W1272-0209

Bulkhead No 5 hold

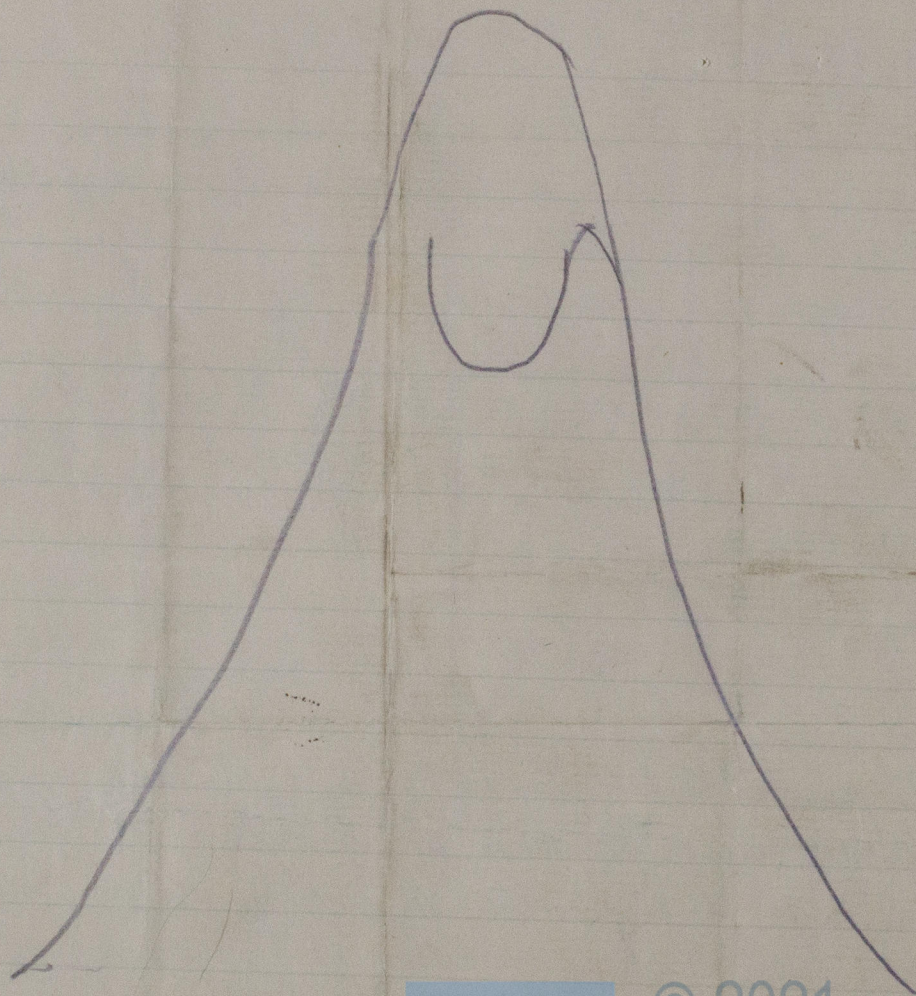
I propose to put a 2 way cock in at the For Bulkhead + lead pipes across to for Lumber, jointing on the Belge pipe in the tunnel independant of the Aft hold well valve up here (note) of course they will be each side of the tunnel Bulkhead close to the floor of the hold then the pipes could be cased over. I think you will be able to follow this. It is owing to the ship
